**LOS ANGELES UNION STATION
FORE COURT AND ESPLANADE IMPROVEMENTS PROJECT**

ADDENDUM NO. 2 TO THE ENVIRONMENTAL IMPACT REPORT

**LOS ANGELES COUNTY METROPOLITAN TRANSPORTATION AUTHORITY
ONE GATEWAY PLAZA
MAIL STOP 99-23-4
LOS ANGELES, CA 90012**

SEPTEMBER 9, 2020

Figure 3 – Modified Project Plan

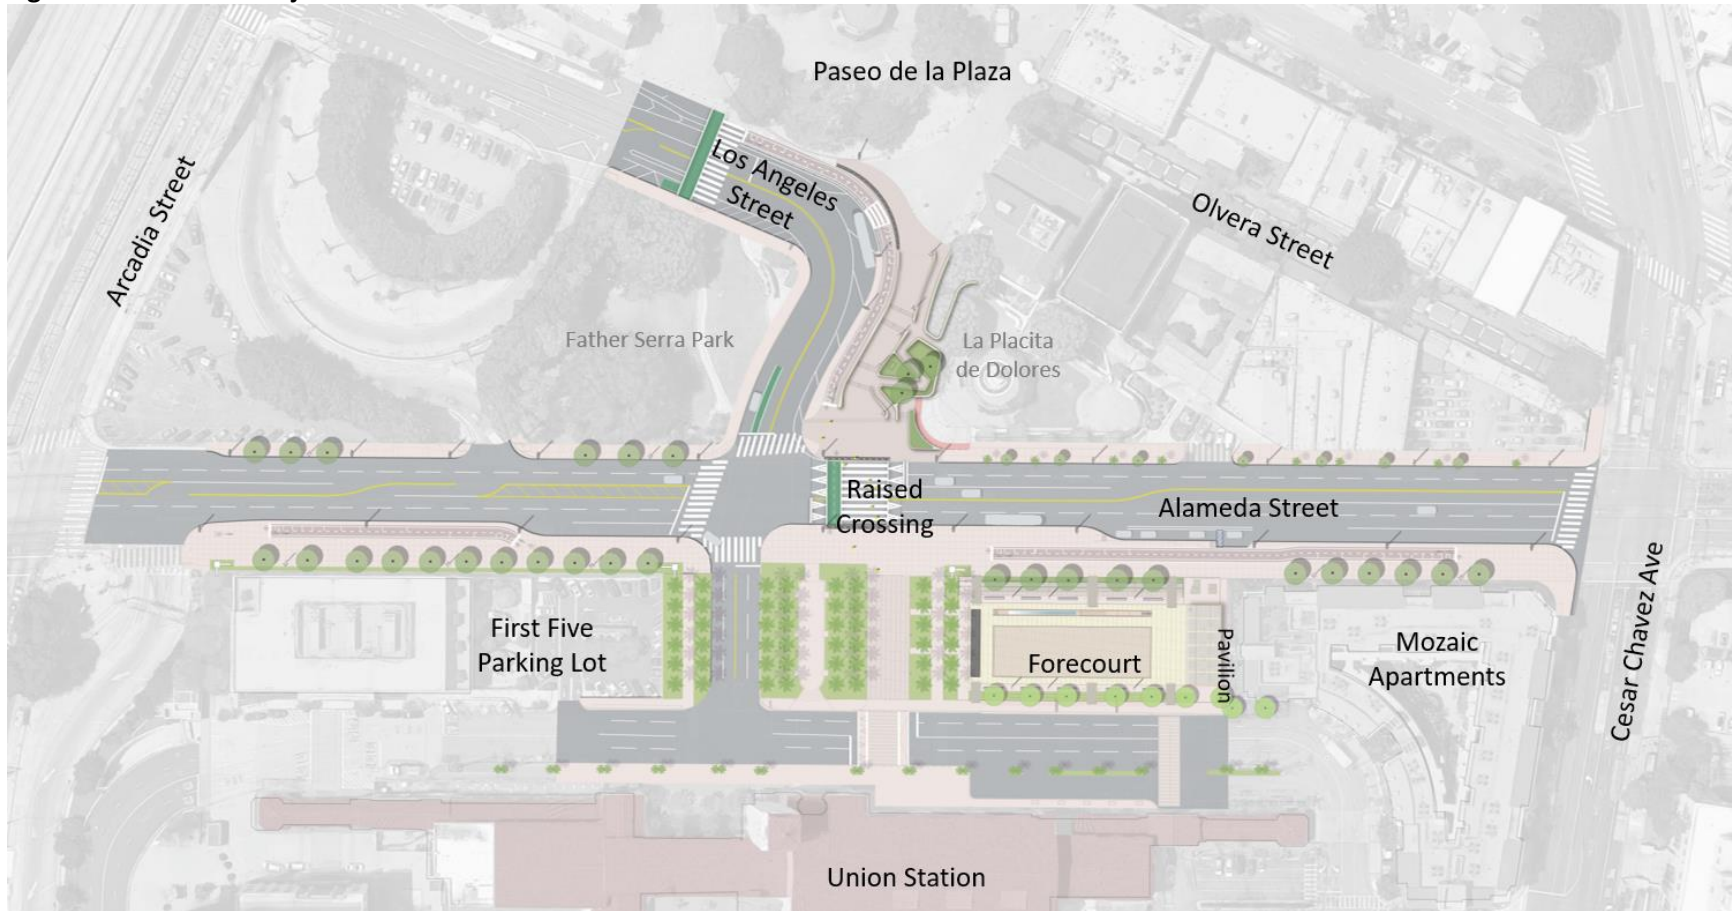
1. Alameda Esplanade Revisions,
2. Intersection and Roadway Modifications,
3. Removal and Replacement of Streetlights,
4. Removal and Replacement of Additional Utilities, and
5. Redesigned ADA-Compliant Los Angeles Street Pathway (**Figure 3**, Modified Site Plan, and **Figure 4**, Proposed Modifications)

Figure 4 – Proposed Modifications

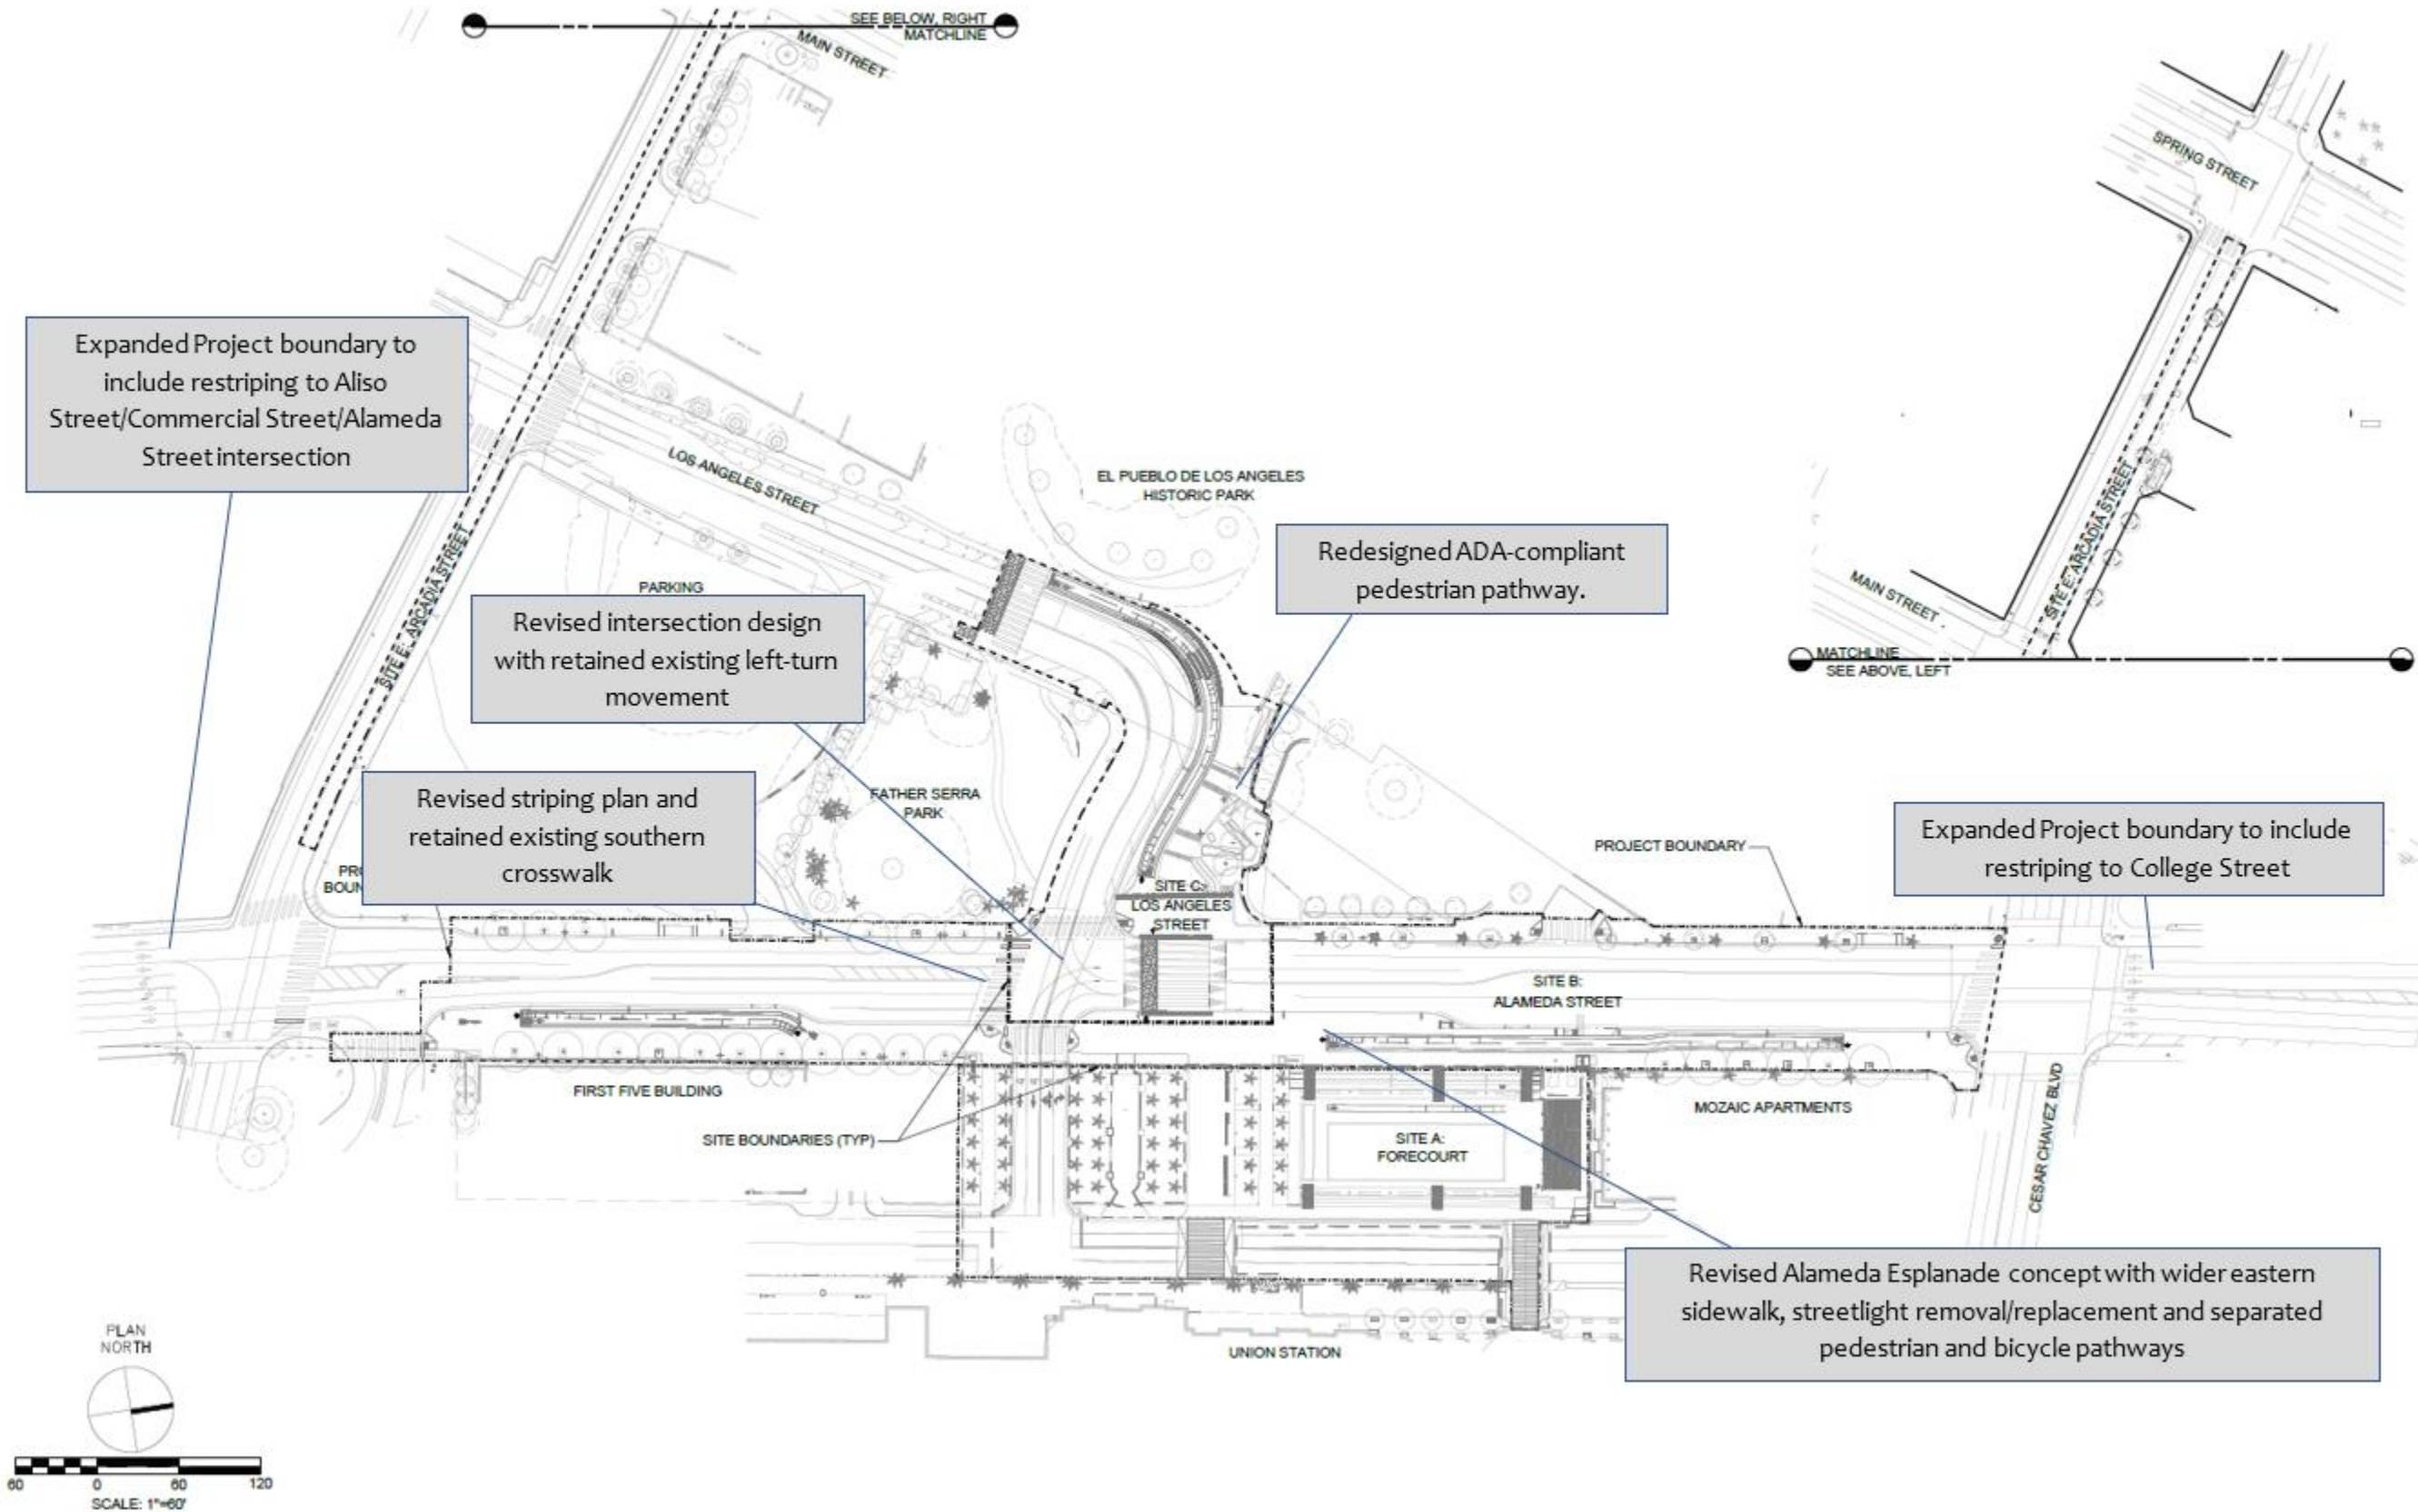
The Approved Project Alameda Esplanade concept in the Certified EIR included the removal of two vehicular travel lanes on Alameda Street, widening of the eastern and western sidewalks, and a new shared pedestrian and bicyclist multi-use path on the eastern sidewalk. As part of the Modified Project under this addendum, two vehicular travel lanes on Alameda Street would still be removed, but all the gained area within the right-of-way would be shifted to the eastern sidewalk to accommodate a separated bicycle and pedestrian path with mixing zones¹⁰ on the eastern sidewalk. Mixing zones will be adequately designed to provide users with advanced notice of the end of the separated paths of travel and the start of a shared, mixed area for pedestrians and bicyclists.

The western sidewalks will be replaced but will be maintained at the same width. Additionally, minor modifications to the sidewalk and pavement leading up to the El Pueblo building face along the west side of Alameda Street would be required under the Modified Project. At the location, the existing pavement slope would be lowered to maintain proper stormwater flow and ADA slope recommendations resulting in a minor expansion (approximately 235 square feet) of the project limits. In addition, the current design depicts a single row of trees along the length of the proposed Alameda Esplanade, while the Approved Project proposed a double row of trees totaling 54 trees within the Esplanade. Though the design has been revised since the Approved Project to address City of Los Angeles concerns related to stormdrain root invasion, Metro is maintaining the original double tree row envelope as part of the Project to provide flexibility. The changes have been advanced because of direction from the City of Los Angeles.
